United States Patent and Trademark Office

APPLICATION NO.	FILING DATE	FIRST NAMED INVENTOR	ATTORNEY DOCKET NO.	CONFIRMATION NO.
10/656,606	09/05/2003	Bruno Devos	BOCK-06/119	8003
26875	7590 08/15/2006		EXAMINER	
WOOD, HERRON & EVANS, LLP			MOON, SEOKYUN	
2700 CAREW TOWER 441 VINE STREET			ART UNIT	PAPER NUMBER
CINCINNATI	 -	2629		
			DATE MAILED: 08/15/2006

Application No.	Applicant(s)				
	10/656,606	DEVOS ET AL.				
Office Action Summary	Examiner	Art Unit				
	Seokyun Moon	2629				
The MAILING DATE of this communication app Period for Reply						
A SHORTENED STATUTORY PERIOD FOR REPLY IS SET TO EXPIRE 3 MONTH(S) OR THIRTY (30) DAYS, WHICHEVER IS LONGER, FROM THE MAILING DATE OF THIS COMMUNICATION. - Extensions of time may be available under the provisions of 37 CFR 1.136(a). In no event, however, may a reply be timely filed after SIX (6) MONTHS from the mailing date of this communication. - If NO period for reply is specified above, the maximum statutory period will apply and will expire SIX (6) MONTHS from the mailing date of this communication. - Failure to reply within the set or extended period for reply will, by statute, cause the application to become ABANDONED (35 U.S.C.

Drawing 1

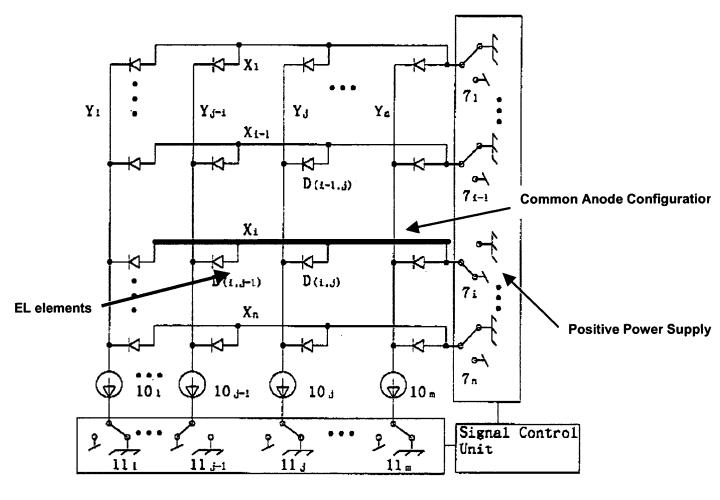
As to **claim 1**, Yeuan [figs. 7 and 10] teaches a method for controlling an electroluminescent display, said display comprising [drawing 1 provided on page 3 of this office action, which is equivalent to Yeuan's fig 10]:

a plurality of EL elements having an anode and a cathode;

said EL elements being arranged in a common anode configuration;

whereby a current source is arranged between each individual cathode of the EL elements and ground and;

the anodes of the EL elements are electrically connected in common to a positive power supply.

Yeuan does not teach the method to comprise power voltage supply compensation.

However, Sakamoto teaches a display apparatus characterized in power voltage supply compensation, in which a voltage drop is measured across an EL element and wherein the measured voltage drop is used as an indicator for the light output of the EL element and wherein a power supply is adjusted in function of the measured voltage drop [col. 2 lines 18-33].
